Application No. 10/628,520  
Amdt. Dated August 23, 2004  
Reply to Office Action of April 21, 2004

## **REMARKS/ARGUMENTS**

Application No. 10/628,520  
 Amendment date: 8/23/2004  
 Reply to Office Action of 4/21/2004  
Annotated Sheet Showing Changes

FIG. 4

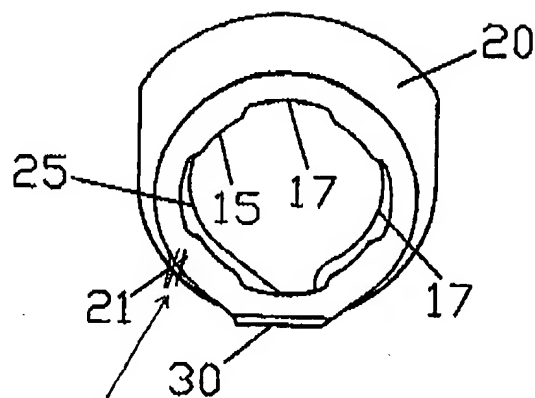
Furthermore, Applicant submitted herein a proposed correction of Fig. 4 to correct a marking error on part 21. Applicant requests the Examiner's consideration and entering of the corrected drawing.

*Change marking  
 to the right  
 position*
